Product Change Notification

Product Change Notification: PCN-21-117017

**General Product Description:**  
GPL 296: AMPMODU MTE HEADER ASSEMBLIES

**OPTIONAL MTE SHROUDED HEADER HOUSING**

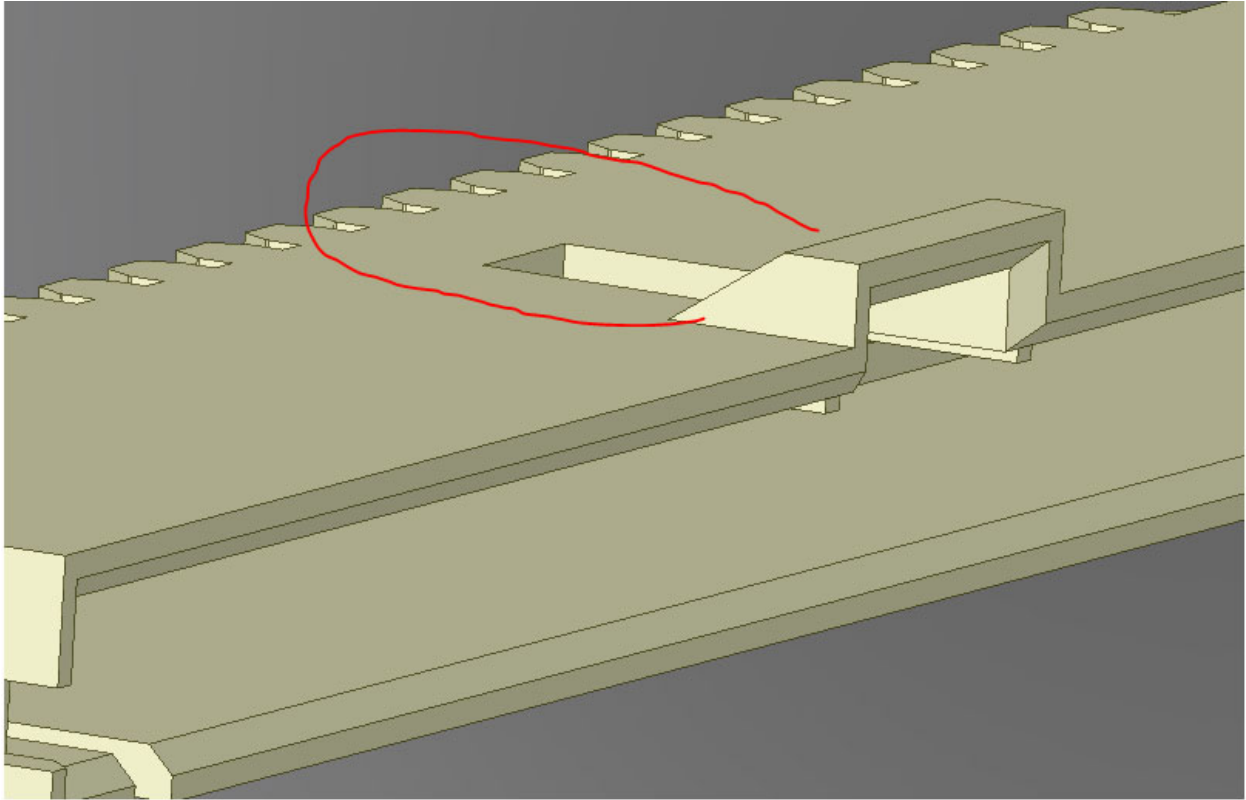
**Description of Changes**  
Allowing the use of up to 50% maximum regrind in the housings. Making tool change at base of housing at the latch area optional at molder's discretion. This tooling change will allow manufacturing an option to prevent flash in the latch area.  
**Other attachments:**  
[Optional Tooling Change](#)

**(Optional at Molder's Discretion)**

**ORIGINAL HOUSING - ACCEPTABLE**

**OPTIONAL HOUSING - ACCEPTABLE**
